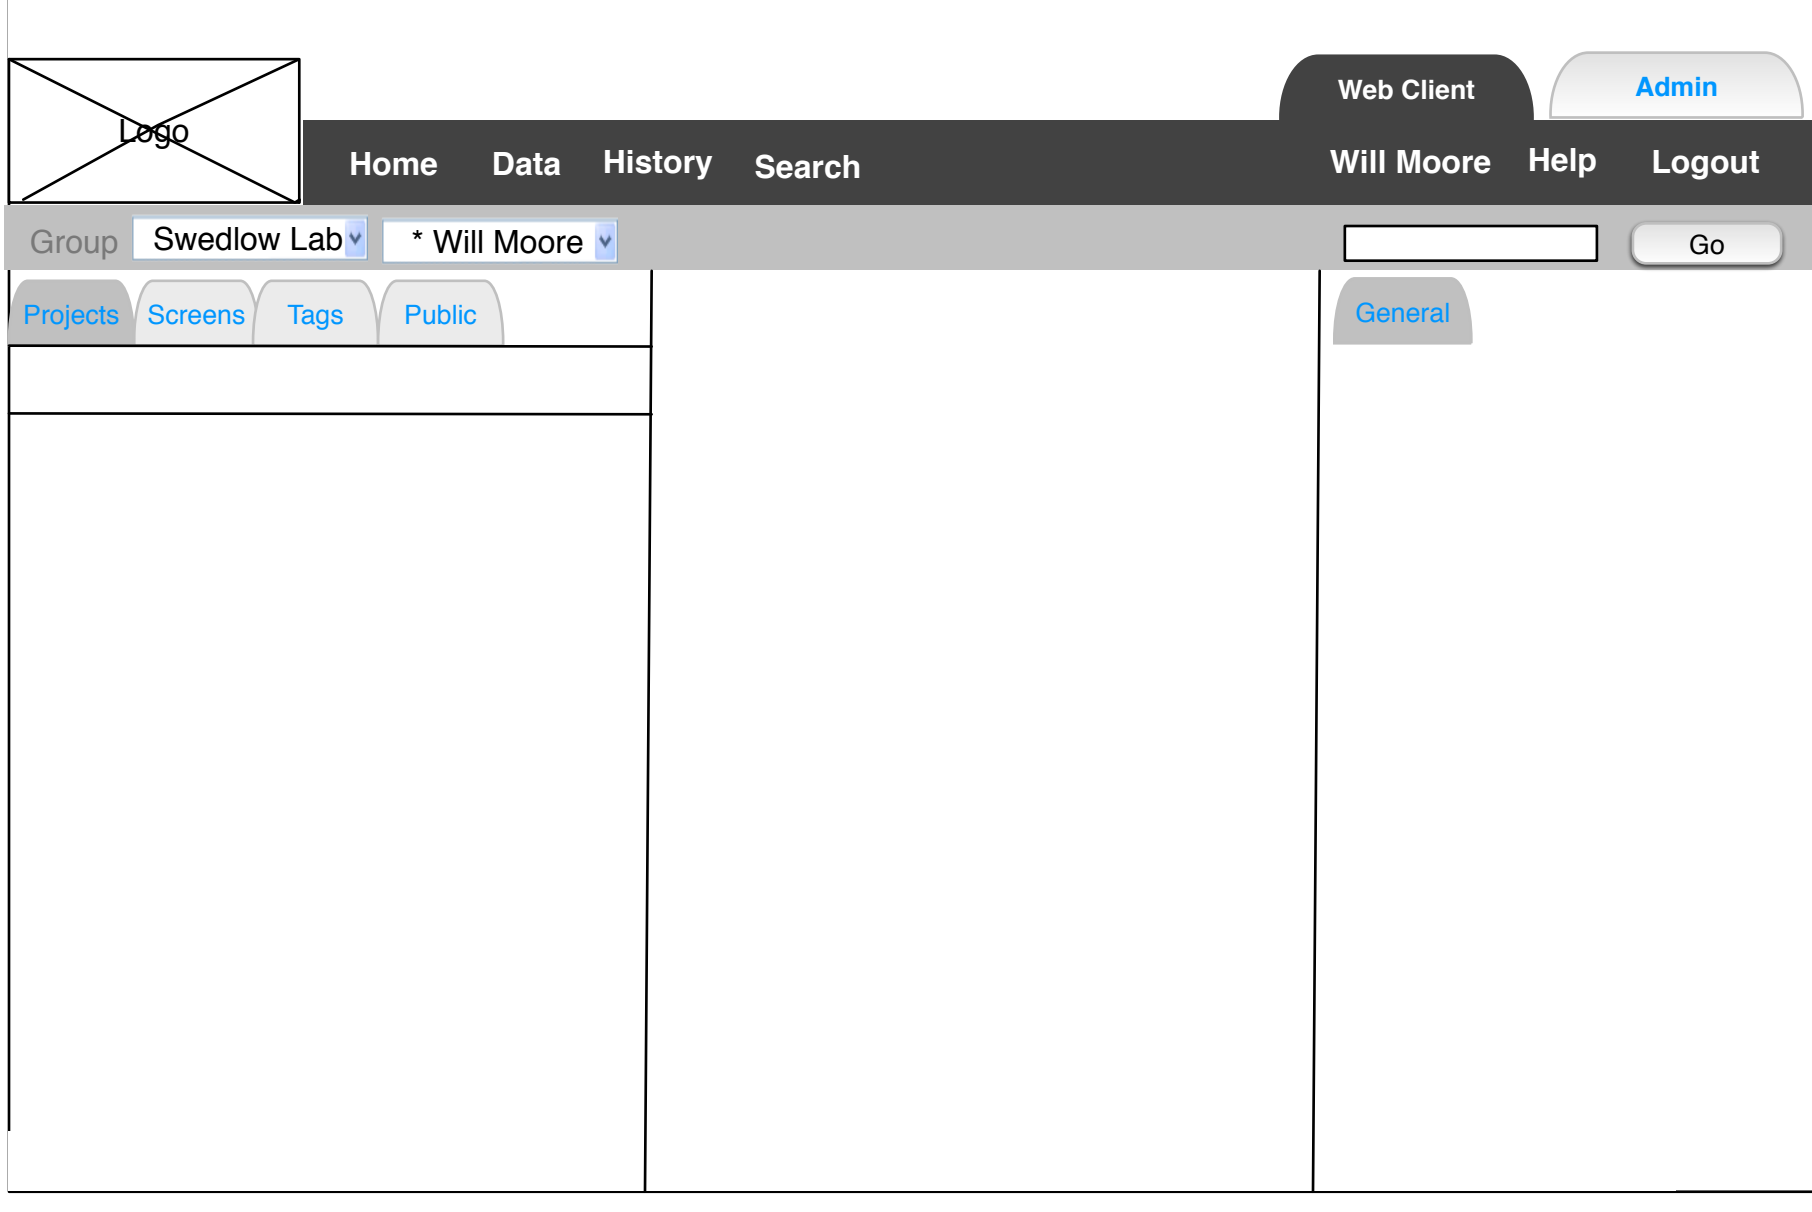
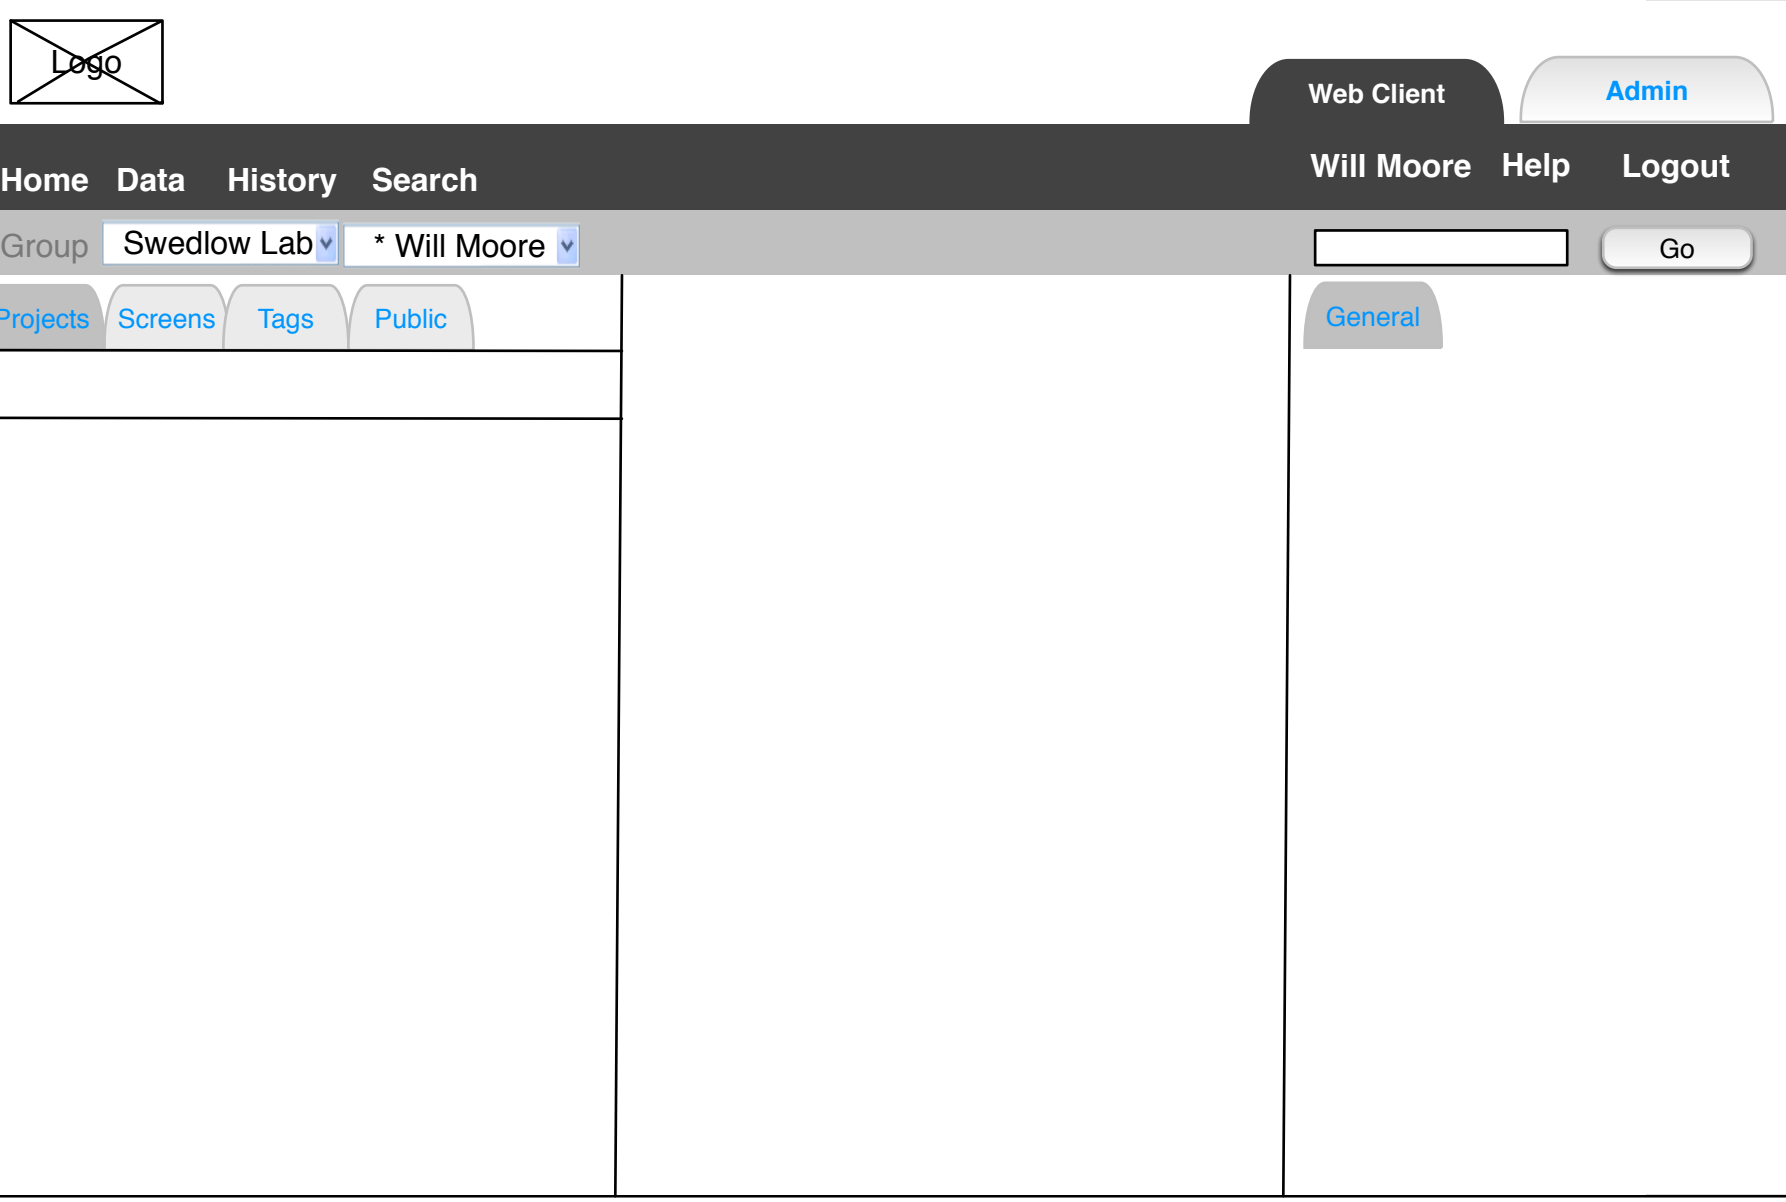
Change in the position of Help and Logout

Button Alternative for user selection

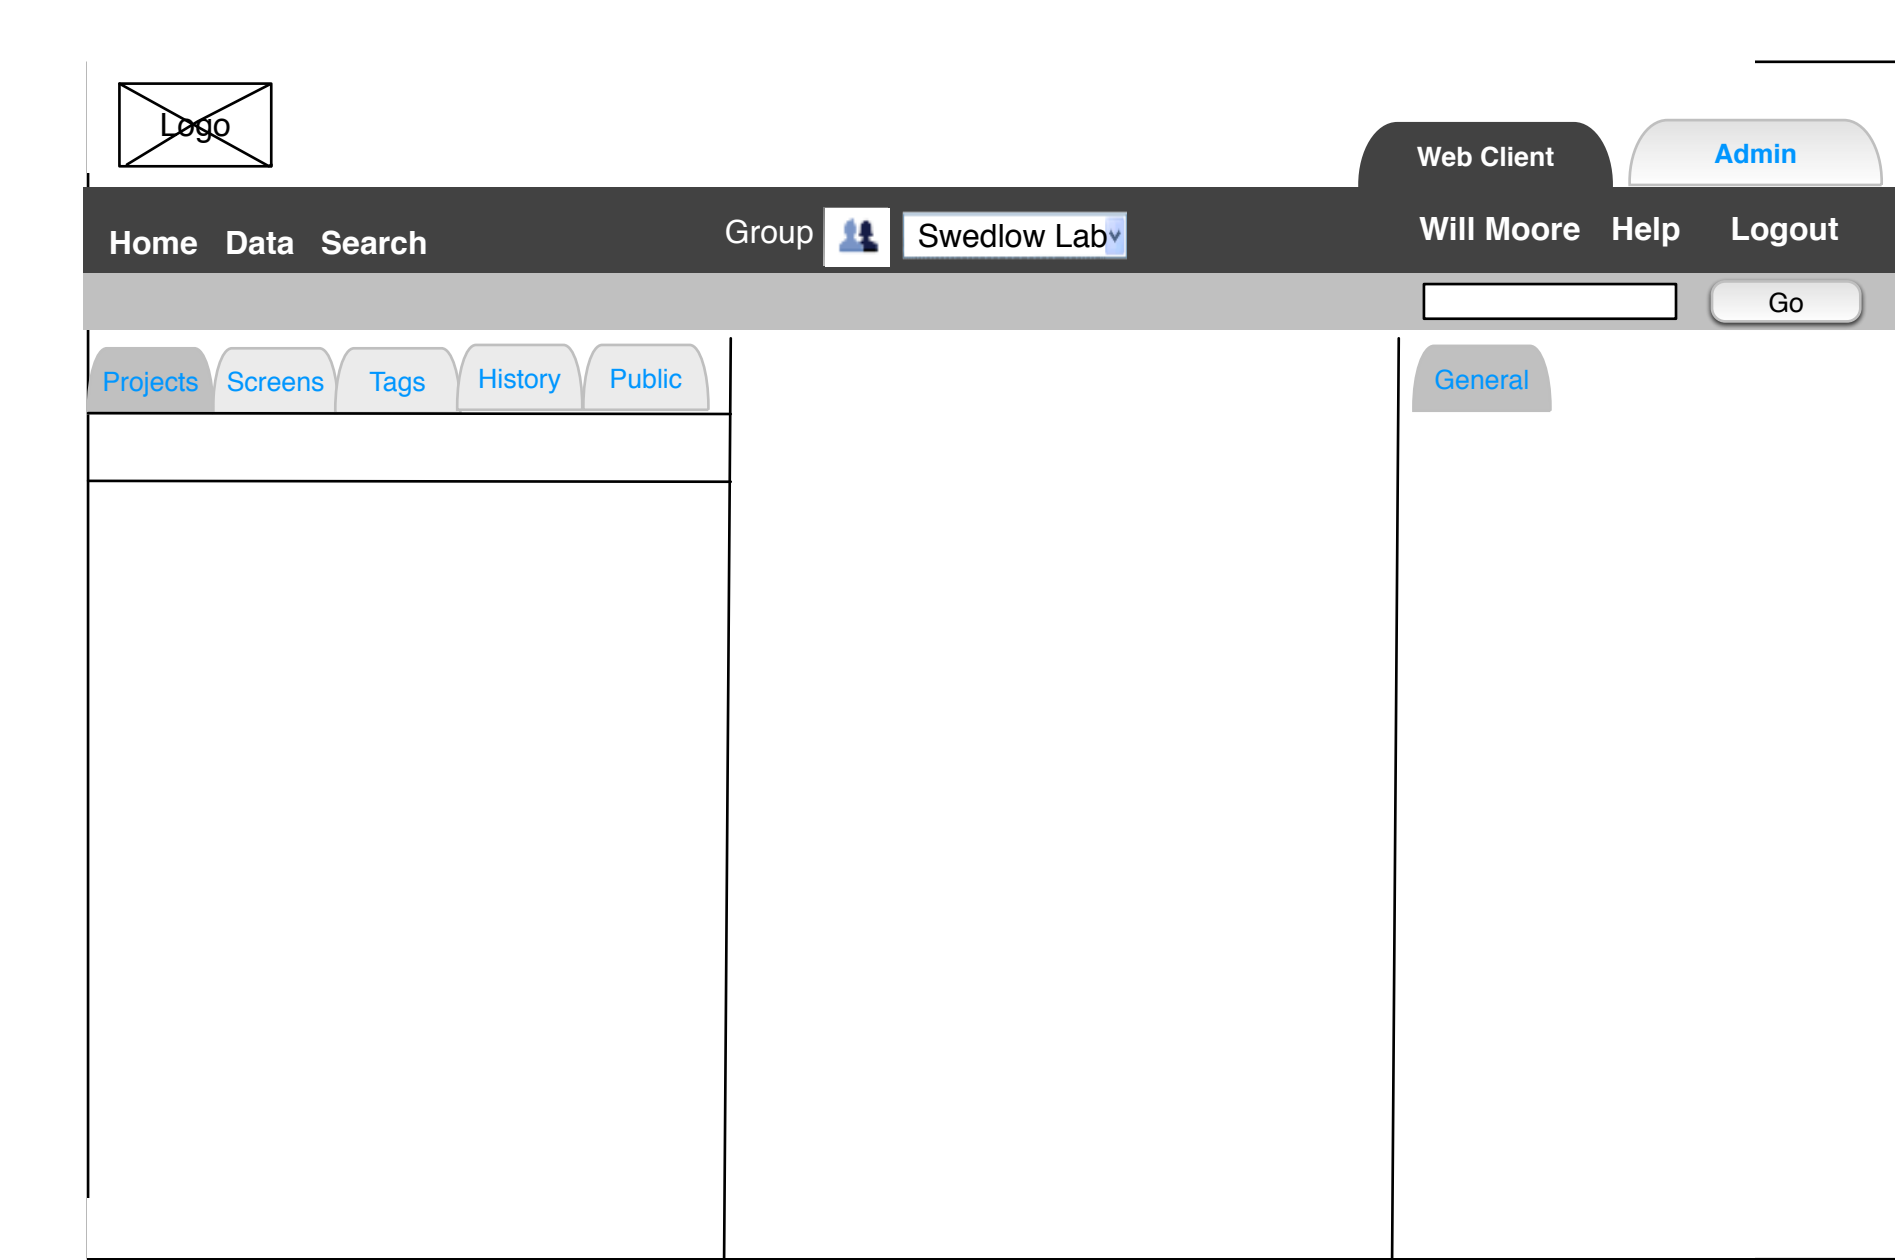
Change in the position of Help and Logout + change in position of History + position of group dropdown box

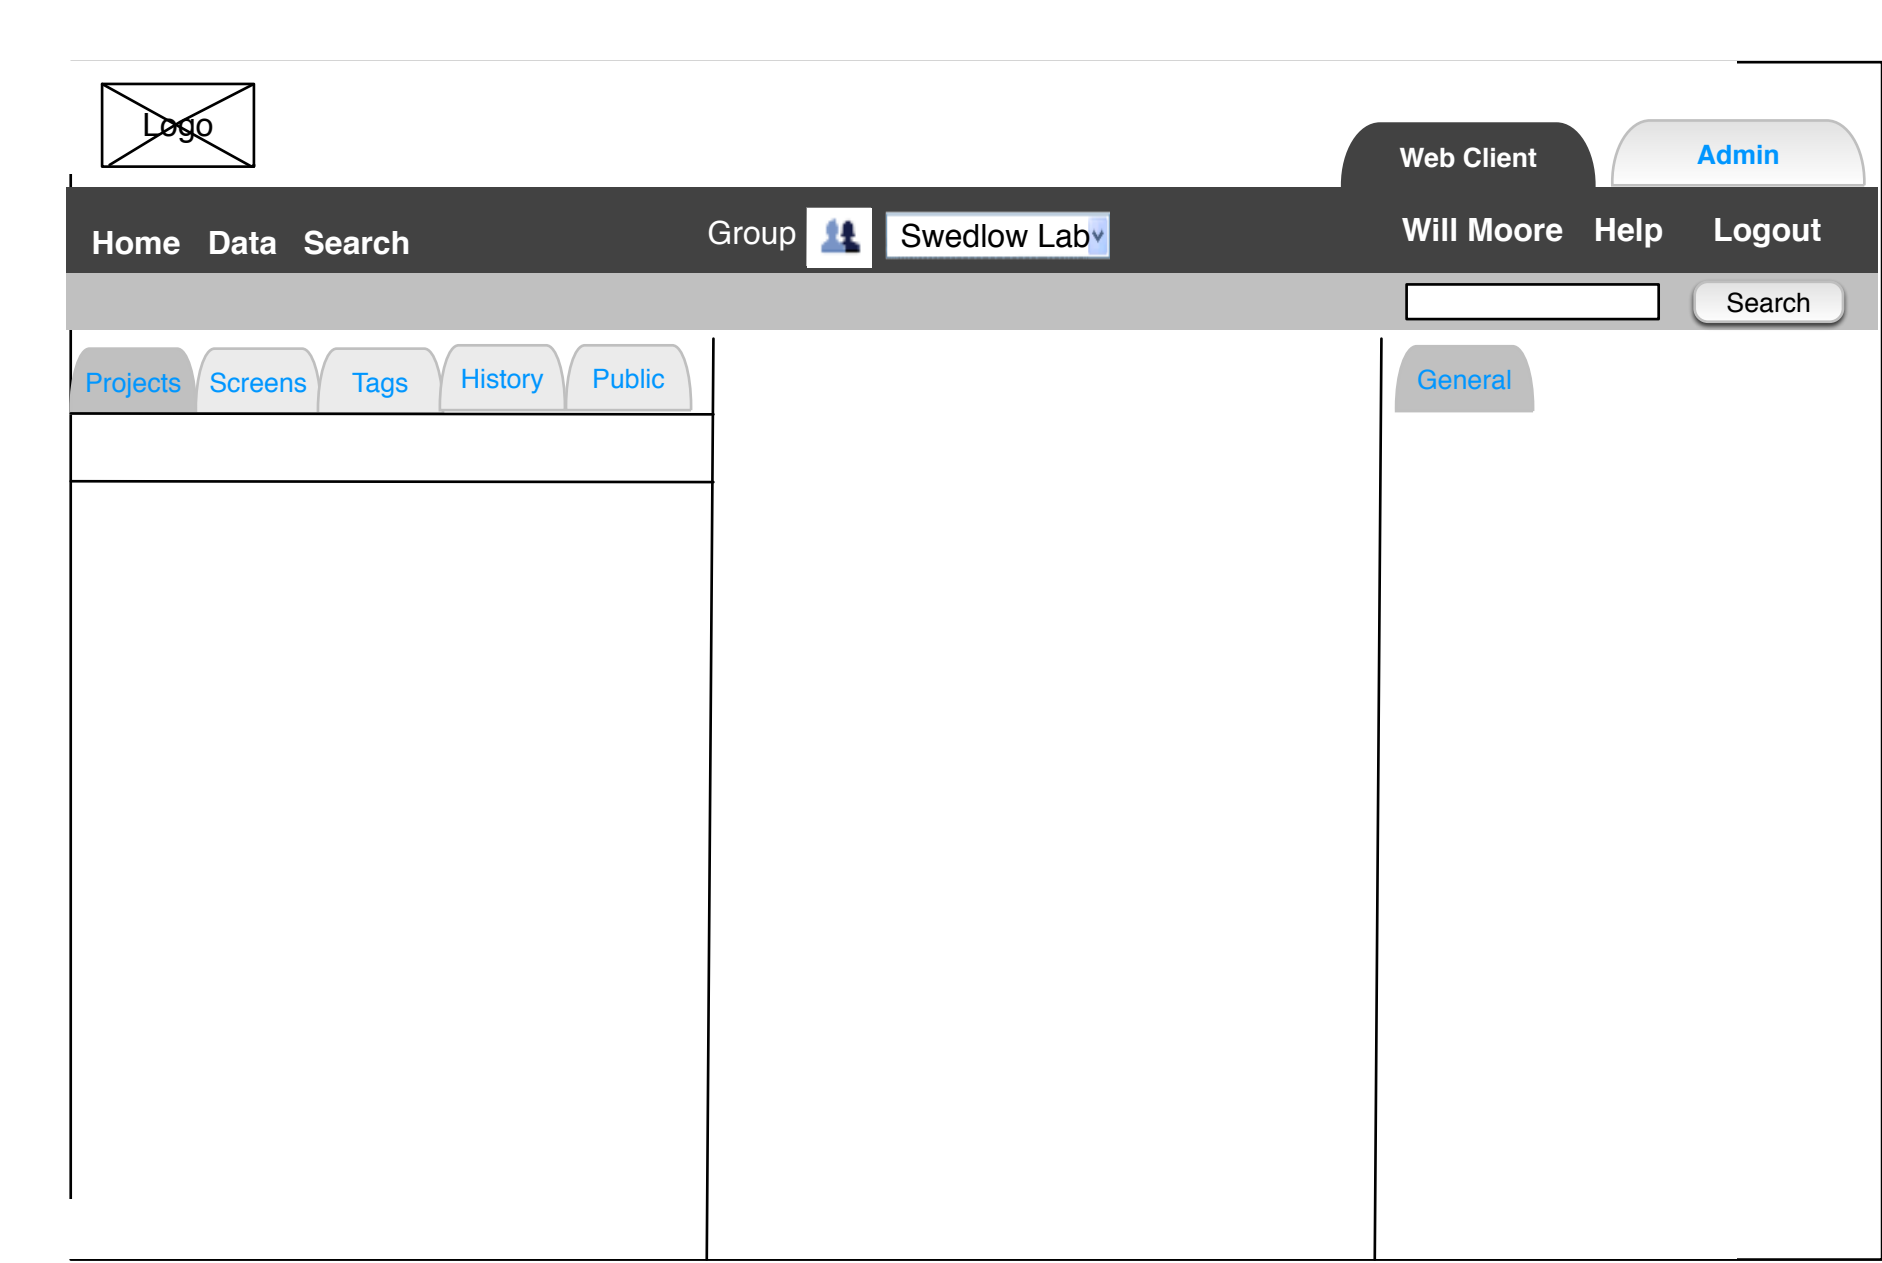
Change in the position of Help and Logout + change in position of History + position of group dropdown box

Change in the position of Help and Logout + change in position of History + position of group dropdown box
